**Enquiries****Please ask for  
Direct****Our reference**Theresa Folpp  
02 6549 3700  
Muswellbrook Solar Farm  
(Folder ID 175802)

**Muswellbrook Solar Farm – Muswellbrook Shire Council Comments on  
Environmental Impact Statement**

**Figure 1 - Land Zoning**

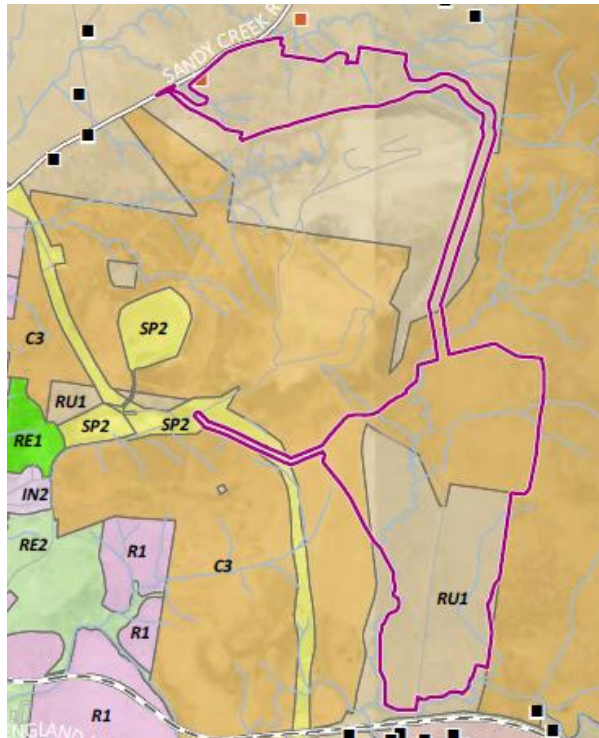
Part of the site is zoned C3 (Environmental Management). Electricity generating works are not permitted within this zone, however the provisions of the State Environmental Planning Policy (Transport and Infrastructure) 2021, allow the proposed Project to be undertaken with consent under clause 2.36 1b, as a prescribed non-residential zone.

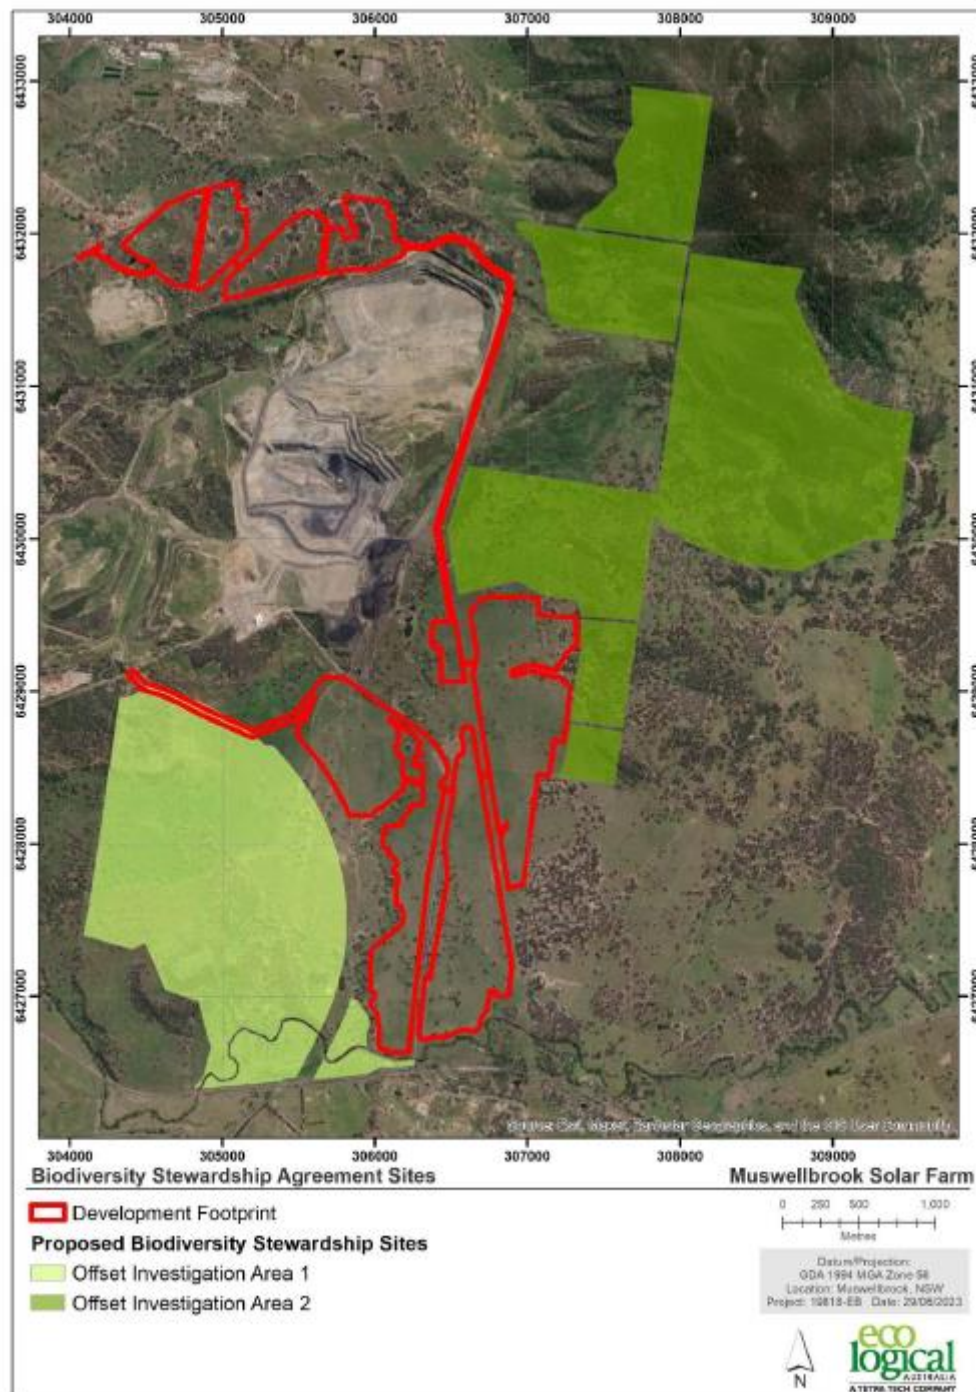
*There are two parcels of land, adjacent to the southern portion of the Development footprint, that are currently being investigated for Biodiversity Stewardship Agreements (see figure below) to offset the residual impact of the Project.*

30. Should the Proponent elect to offset the residual impact of the Project in the proposed areas shown in the Offset Investigation Areas (see figure below), it is crucial that they engage in a proactive and strategic approach to biodiversity enhancement. This should go beyond passive management techniques and encompass active measures such as targeted native vegetation planting, habitat restoration, and other conservation initiatives. The strategy should be developed in consultation with local environmental experts, Aboriginal representatives (to ensure a comprehensive species list) and authorities to ensure its effectiveness and alignment with the region's conservation goals and to avoid restricting logical urban expansion of Muswellbrook.
